Access Compliance Report Public Rights-of-Way (Curb Ramps)

Intersection ID: 29989 Main Street: ROZZELLES_FERRY_RD Cross Street: WINDING_RIVER_DR Location: S

ADA ID: 63A9497C1E3B Ramp Type: Para Initial Pass/Fail: Fail Overall Compliance: No Severity Score: 22.5

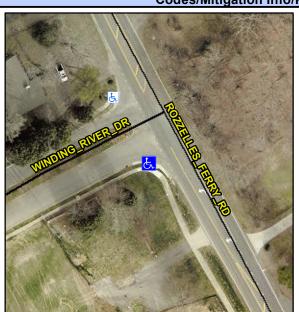
LT RP < 5%

R304.5.1, R304.5.3, R304.3.2

Remove & Replace Entire Ramp.
